Re: Montgomery County  
MD 118  
Tony's Car Wash  
File No. 1-03040

Re: Stormwater Management **CONCEPT** Request  
for Tony's Car Wash  
Preliminary Plan #: 1-03040  
SM File #: CN 206305  
Tract Size/Zone: .94 Ac/C-3  
Total Concept Area: .94 Ac  
Tax Plate: EU 342  
Parcel(s): 742, 770  
Watershed: Great Seneca Creek

Reference: Tony's Car Wash Noise Study

SOUND TEST OF SONNYS AIR DRYER  
DECEMBER, 2000  
(TECHNICAL)

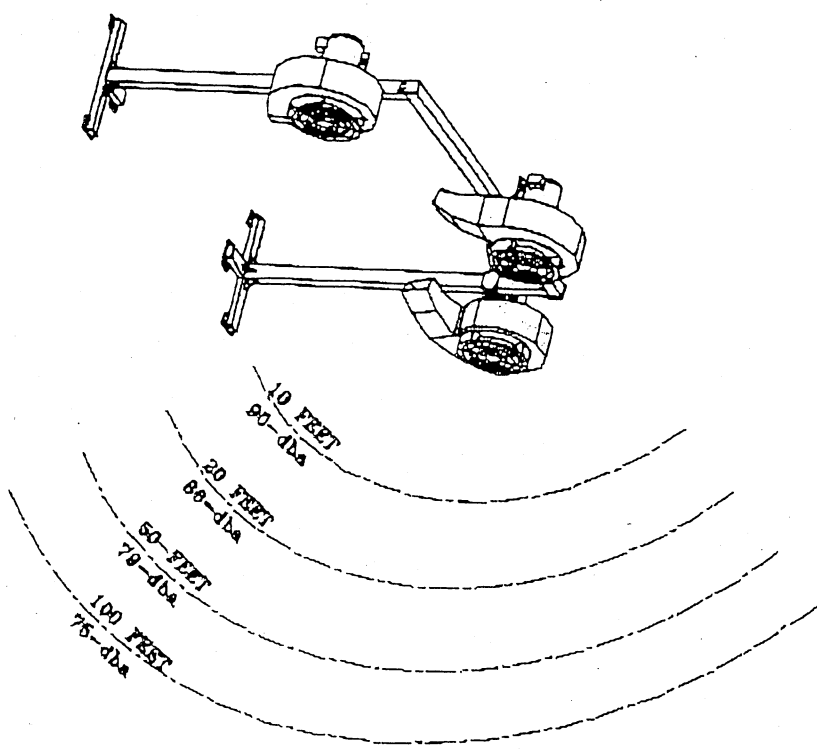
The Sonny's sound test of December 2000 data sheet indicates the sound level of 90 dB(A) measured at a distance of 10 ft outside the tunnel exit opening. That measurement was performed in a real installation for three operating blowers. We estimate that eight proposed blowers will produce the sound level of approximately 92 dB(A) at the same position. The manufacturer could not provide noise data for the opposite, entrance end of the tunnel.

Figure 1. One Acceptable Wood Noise Wall Design

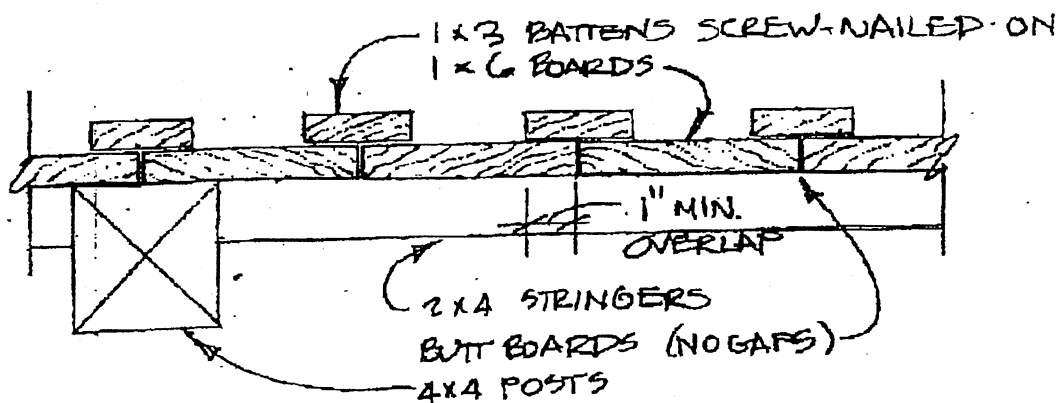
The blower noise at the property line is expected to exceed by approximately 2 dB the level of 65 dB(A) required in daytime for the receiving residential noise areas. Since this will occur only in a limited area in front of the car wash tunnel opening but not farther along the property line, the blower noise can possibly be tolerated in comparison with the high ambient traffic noise at the site. Alternatively, construction of a 6-ft high wood fence is recommended along the property line (in position of the noise wall shown on the site plan). For this case, one possible wood fence design is shown in Figure 1.

- NOTES: A. ENSURE THAT THERE IS NO GAP BETWEEN THE BOTTOM OF THE 1x6 BOARDS AND THE GROUND ACCOMPLISH THIS BY:
1. BURYING THE BOARDS IN EARTH, OR
  2. INSTALLING GRAVEL, OR
  3. LAYING A PRESSURE-TREATED 2x, 4x, OR 6x BOARD AT GRADE AND FASTENING TO THE 1x6 BOARDS
- B. IF A GAP IS USED BETWEEN BOARDS, THIS IS ALLOWABLE PROVIDED THE GAP IS NO MORE THAN 1" AND 1x4 BATTENS ARE USED
